**Addendum No. 1**  
**January 12, 2024**

Project: **Lennox High School Addition**  
Lennox, South Dakota  
Architecture Incorporated Project No.: 2982

ROOF PLAN

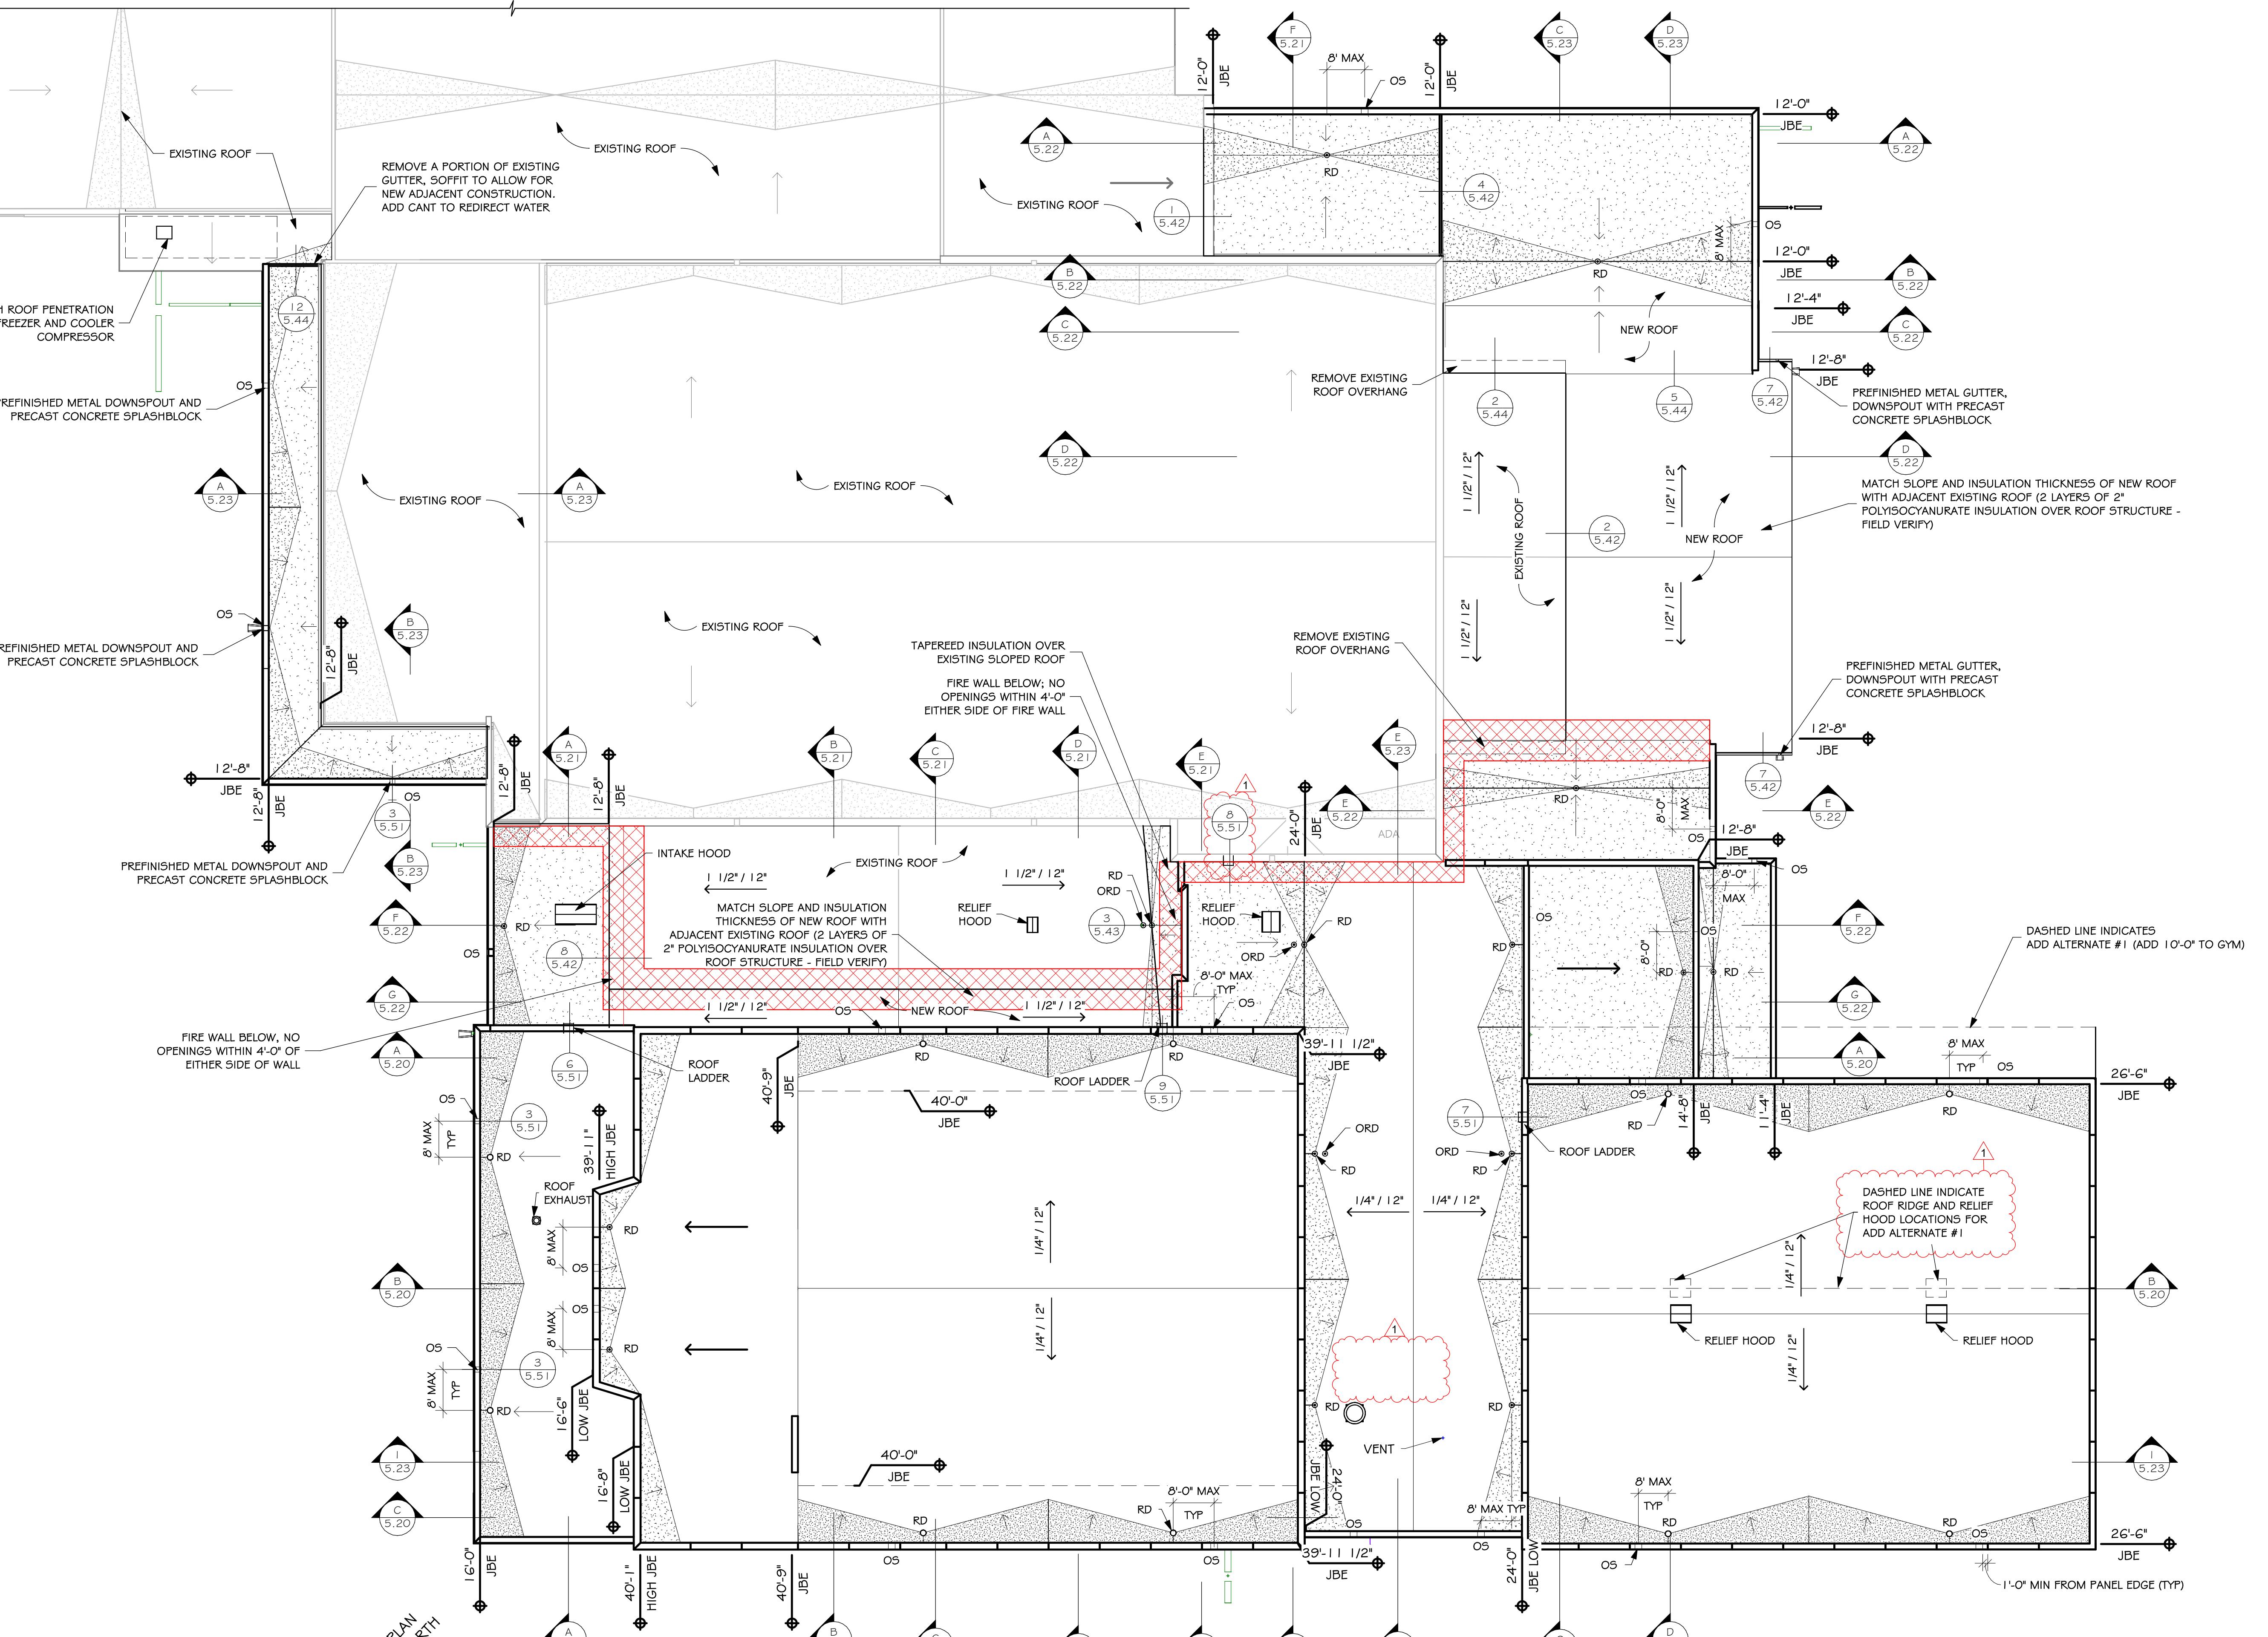
- 19) SHEET 5.50 – ROOF PLAN
- a) Reference *revised* drawing Sheet 5.50, dated 1-11-24, attached to the end of this addendum for the following:
    - i) Omit the roof access hatch shown over Mechanical Penthouse G207; not required.

- ii) Add an exterior roof ladder at the location shown per *revised* drawing Sheet 5.50.
- 20) SHEET 5.51 – ROOF DETAILS
- a) Reference *revised* drawing Sheet 5.51, dated 1-11-24, attached to the end of this addendum for the following:

8 ROOF LADDER SECTION

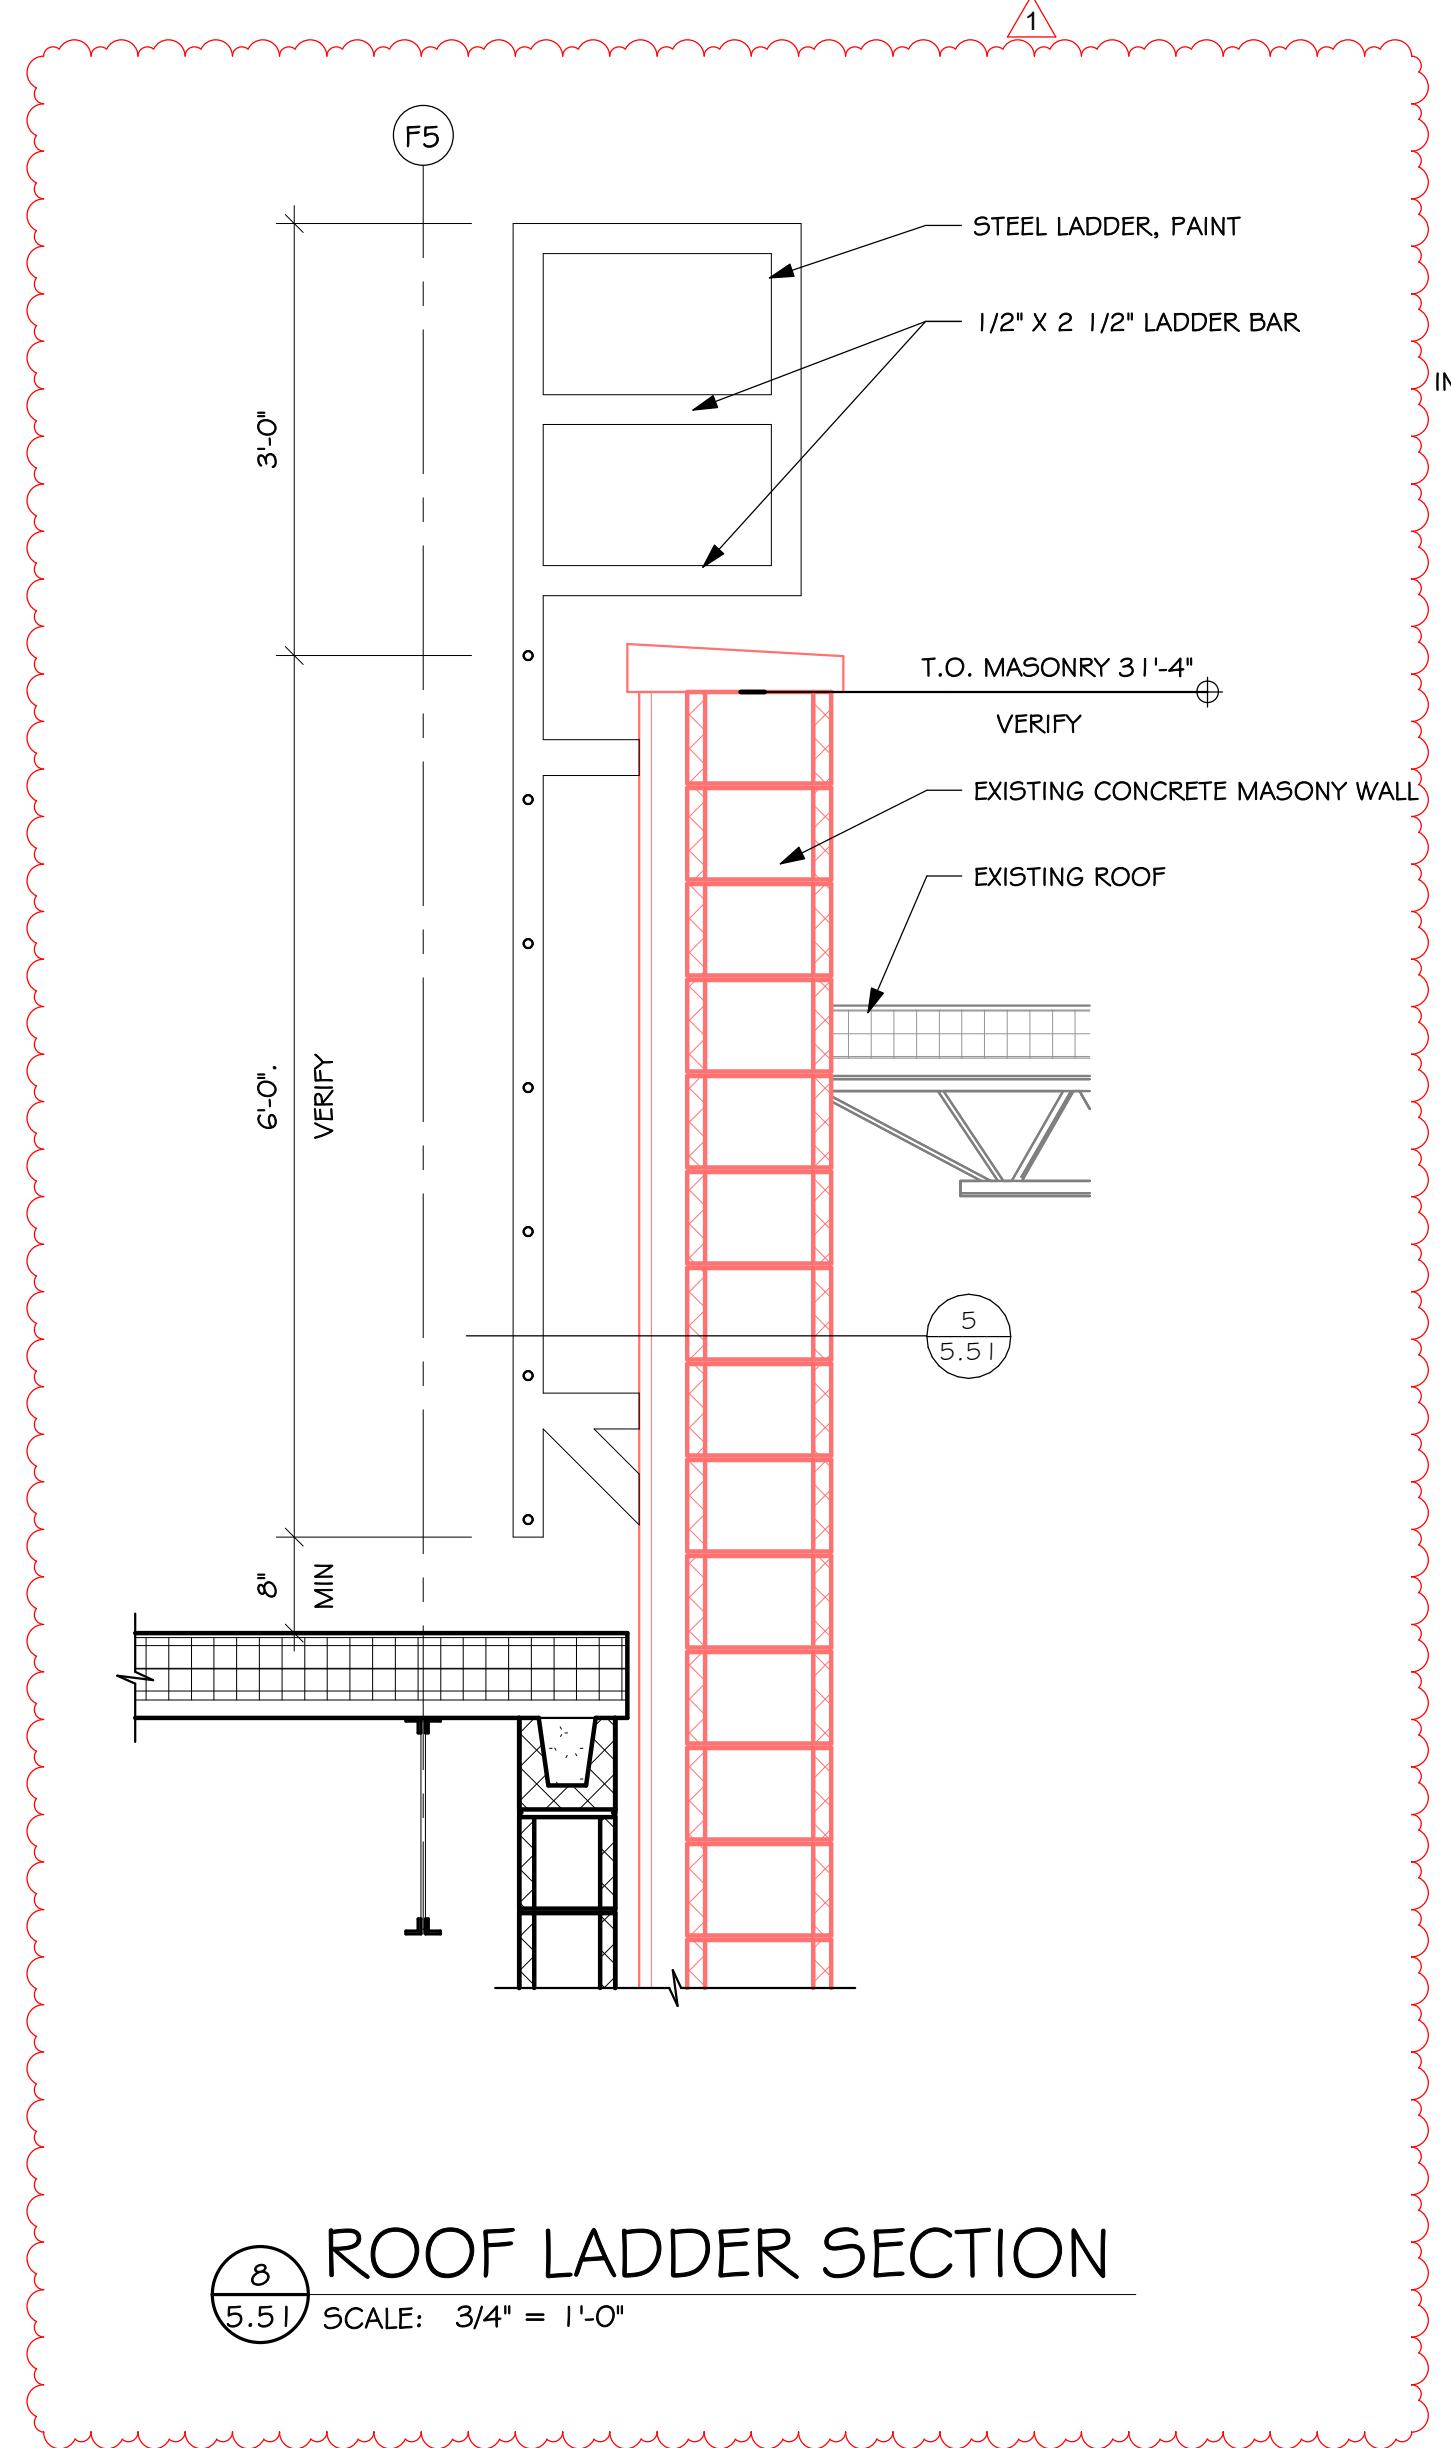
- c) Reference new / updated roof ladder detail section 8/5.51 on *revised* drawing Sheet 5.51. This detail shall apply to the newly added exterior roof ladder between grids GH & GJ.

10 LADDER BAR DETAIL

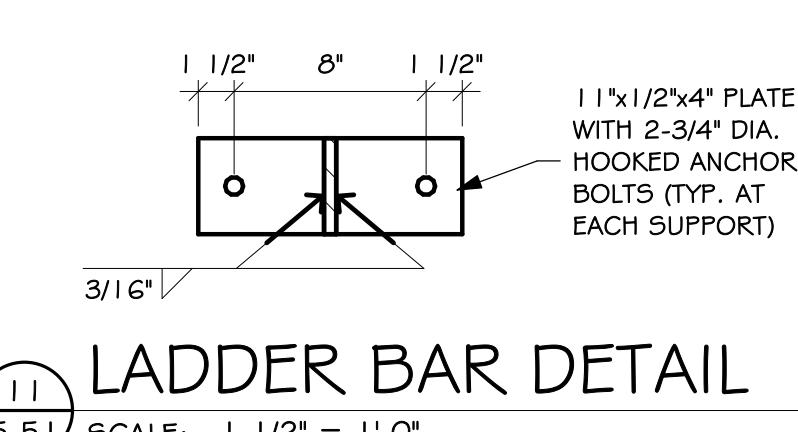
- b) Omit roof hatch detail 10/5.51; not required.
